# NONRESIDENTIAL SITE PLAN APPLICATION City of Rochester, New Hampshire

Re: Drainage Narrative
Colony Used Auto Parts
Off Milton Road
Rochester, NH
Tax Map 205, Lot 134

Site Review Application Colony Used Auto Parts Off Milton Road Rochester, NH Tax Map 205, Lot 134

With respect to the original TRG Comment letter we submit the following:

INFILTRATION & SUBDRAIN DETAIL TYPICAL

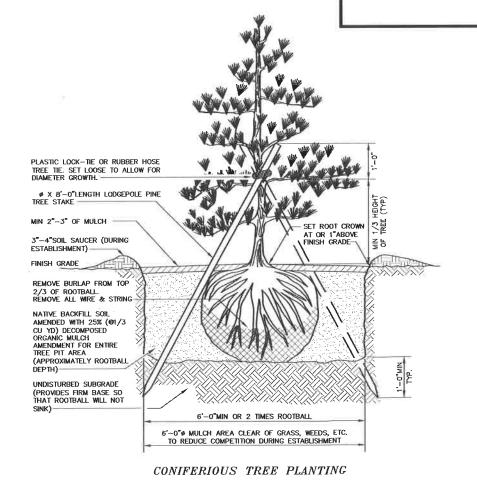
• Need to see some drainage calcs or estimates. Cannot just claim it is sandy so it is okay. It is recognized that Hinckley soils have saturated hydraulic conductivities that are high or very high, but some sort of calculation or show of how the runoff will travel, be dealt with, will be retained without overflow is needed.

- O The slope is a constructed slope which will have 4" loam and seed applied along with the Curlexx II for construction stabilization.
- What catches the rain off the roof or prevents channeling of flow?

- o A drainage narrative is now provided along with a 100 YR/24Hr. analysis of the infiltration drip edge proposed.
- Curlex II Matting, will that be permanent? What will be stabilizing the slope in the long term? Is that the grass detail?

- o An infiltration drip edge is now proposed.
- Where is the grass swale going?
  - o This detail has been removed.
- Eliminate blank details if they are not going to be used.

- 6" crushed stone around building? Stone or gravel?
- o There will be a 2' drip edge against the building constructed of 3/4" stone. There will be an access pad around the front entrance and three supporting sides constructed of 6" crushed gravel.
